NTSB No. CEN15MA290

Airbus Helicopters Service Bulletin No. AS350-67.00.64 (63 Pages)

SUBJECT: ROTOR FLIGHT CONTROLS - Double hydraulic servocontrols

"HYDR" test indication for double hydraulic servocontrols
 Corresponds to modification 074622

Figure 9

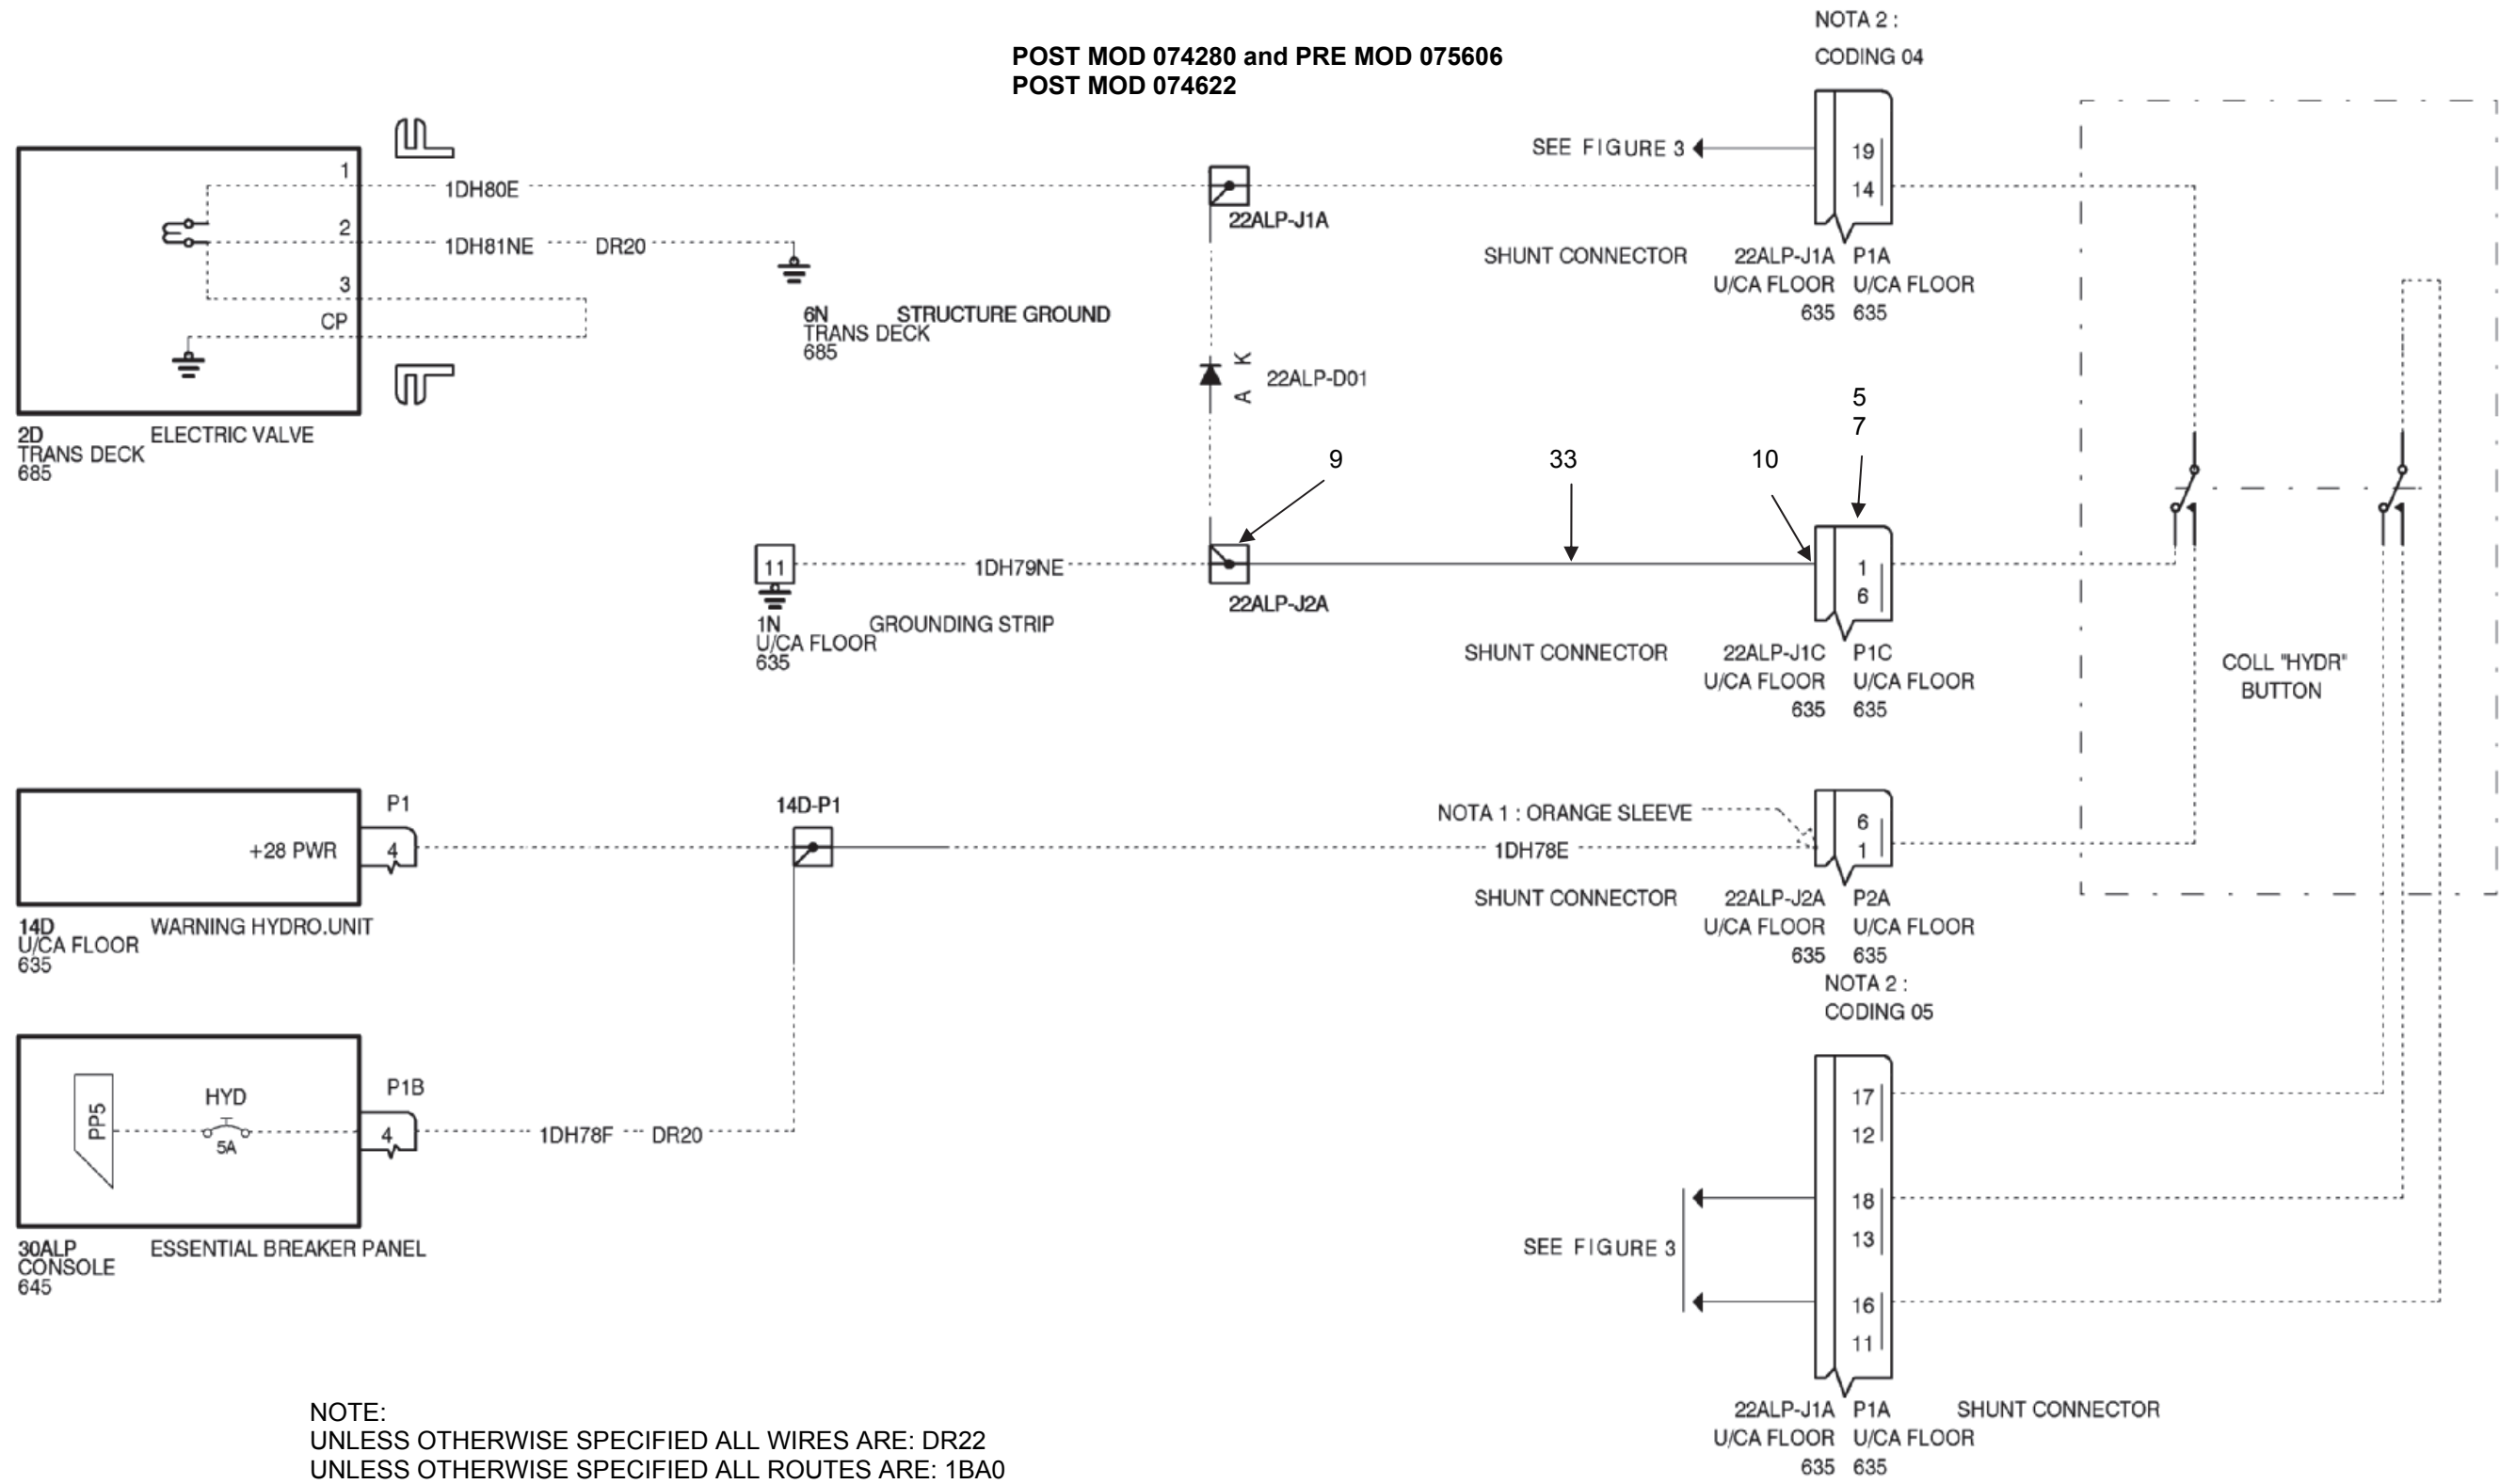
3.B.2.b.3. For helicopters POST MOD 074280 and PRE MOD 075606 (Figures 1, 3, 8 and 9)

- Cut and discard the binding clamps (not shown on Figures) that hold the electrical harnesses.
- Install base (3) on relay support (14) (Figure 1) with its bolts and nuts.
- Route the wiring using sets of wires and markers (1) and (33) and wire to contacts (4), (8), (10) and (11), ground contacts (12) (refer to appendix 4.A.), extensions (9) and (19), module (5) and its adapter (7), as per Figures 3, 8 and 9.
- Carry out a continuity test of the modified wiring.
- Install timer relay (2) on base (3).
- Attach the electrical harnesses with binding clamps (31) or (32) (not shown on Figures).

Figure 10

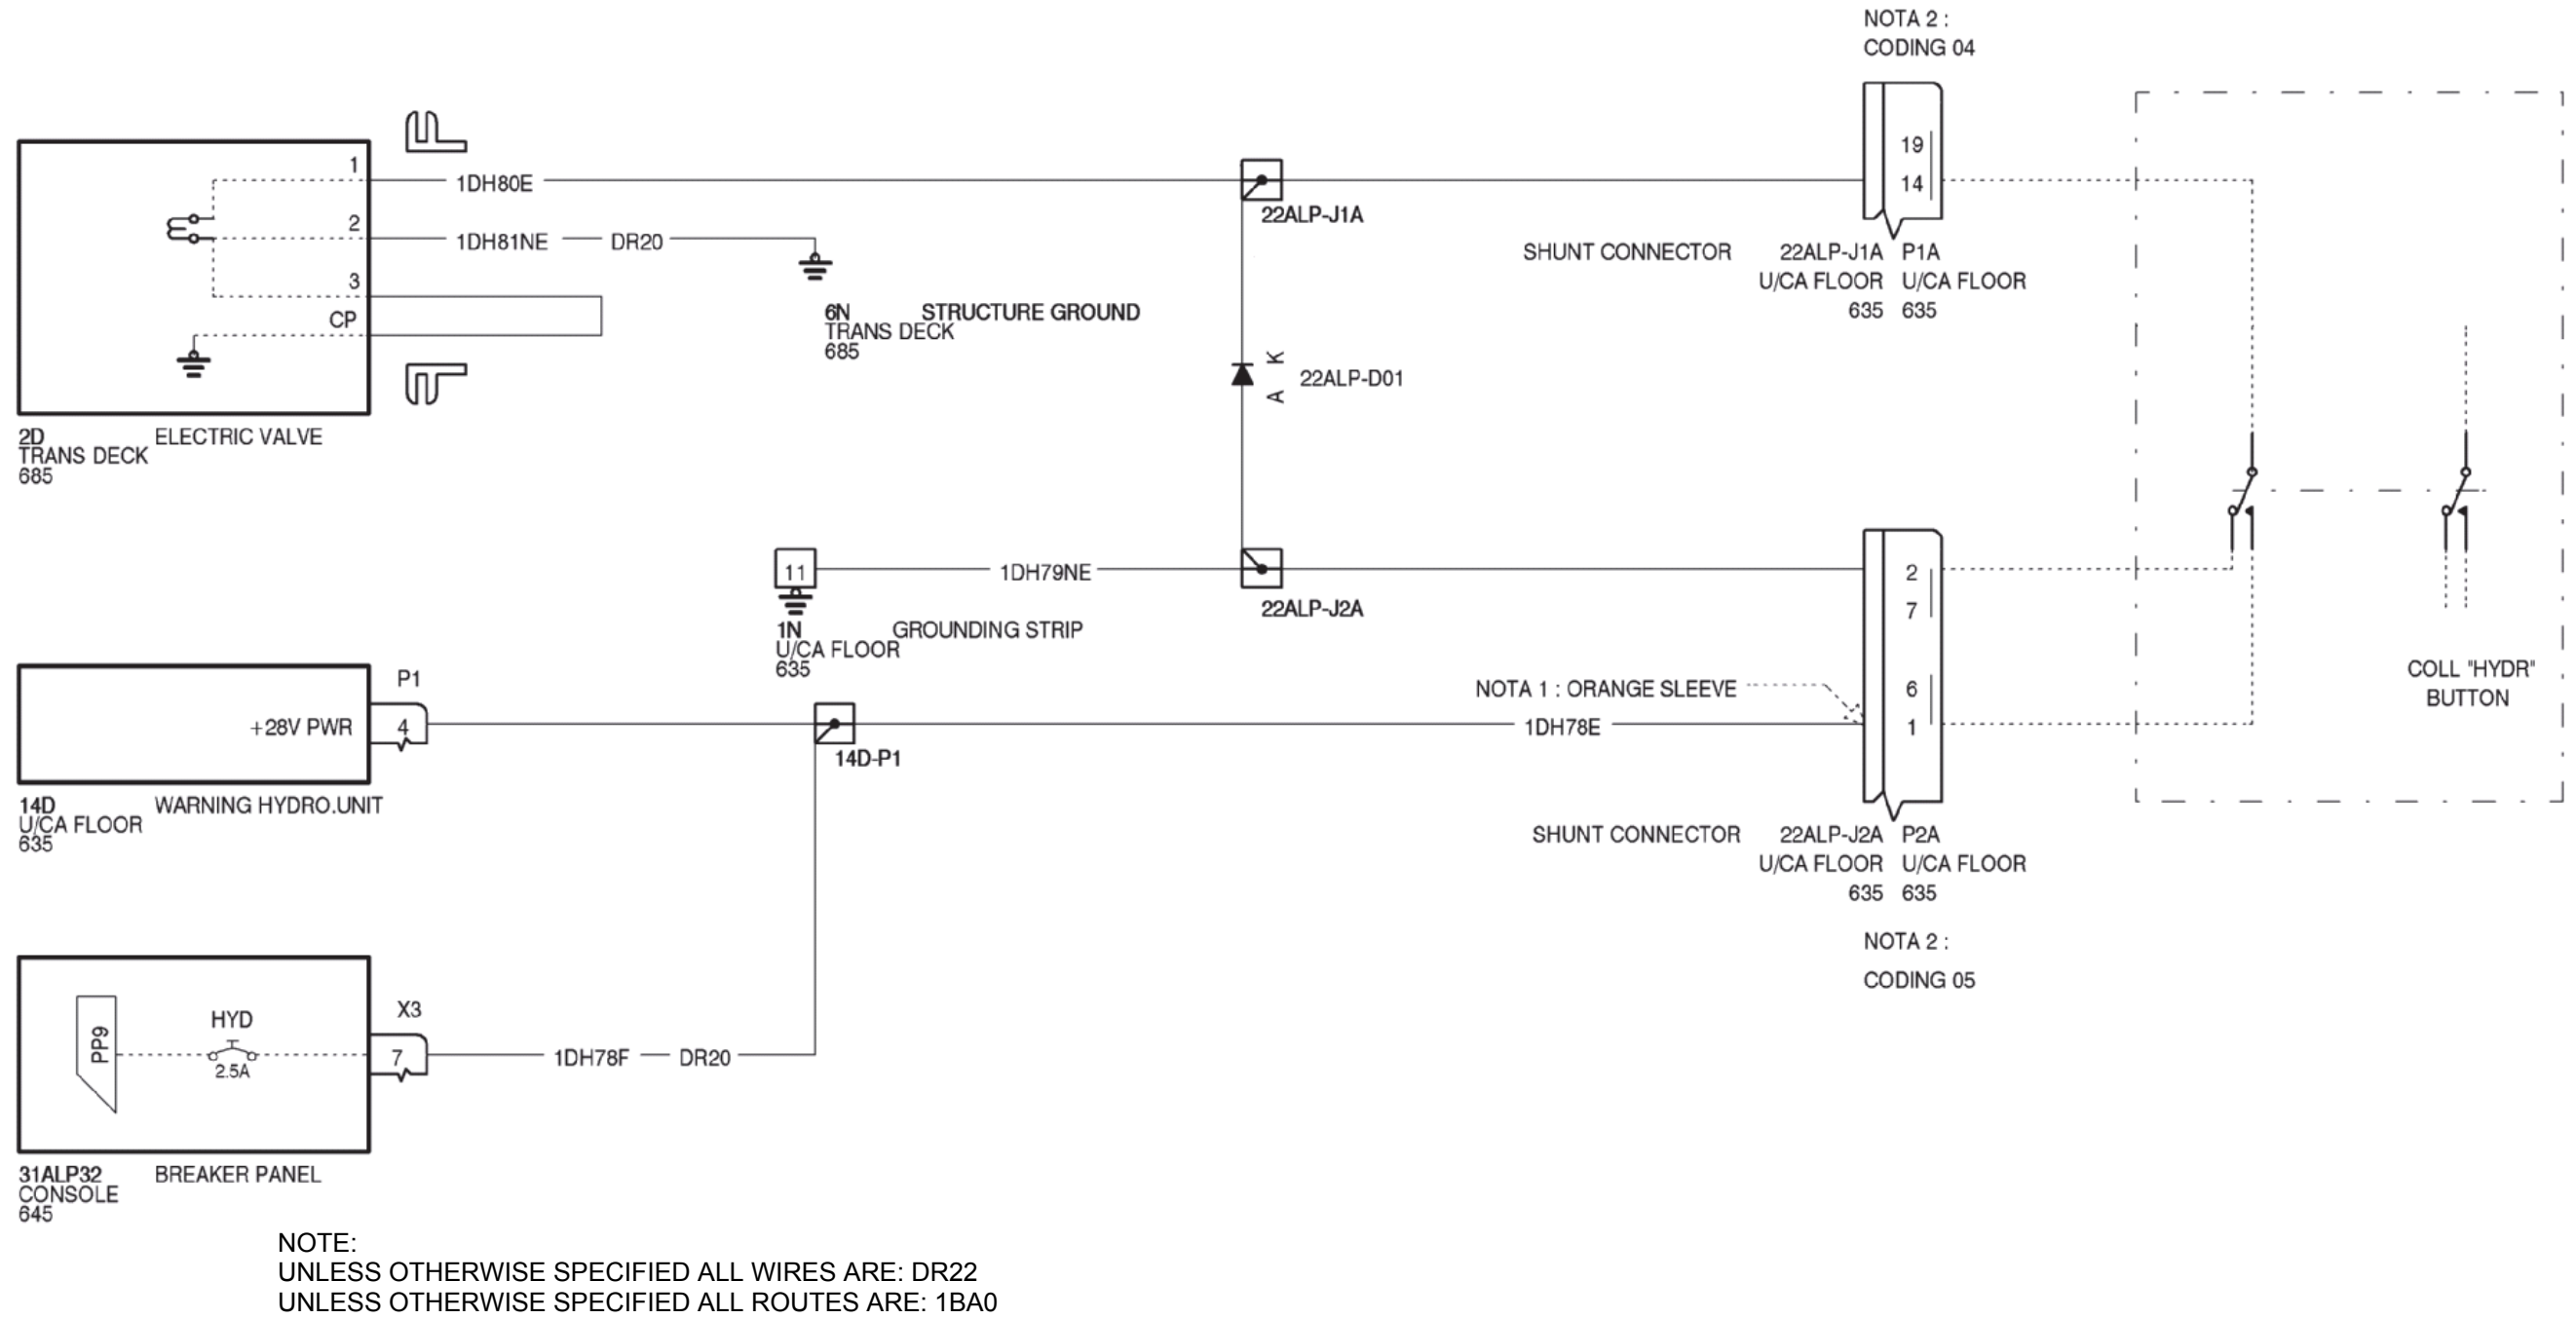
3.B.2.b.4. For helicopters POST MOD 075606 (Figures 1, 3, 10 and 11)

- Cut and discard the binding clamps (not shown on Figures) that hold the electrical harnesses.
- Install base (3) on relay support (14) (Figure 1) with its bolts and nuts.
- Route the wiring using sets of wires and markers (1) and (33) and wire to contacts (4), (8), (10) and (11), ground contacts (12) (refer to appendix 4.A.), extensions (9) and (19), module (5) and its adapter (7), as per Figures 3, 10 and 11.
- Carry out a continuity test of the modified wiring.
- Install timer relay (2) on base (3).
- Attach the electrical harnesses with binding clamps (31) or (32) (not shown on Figures).
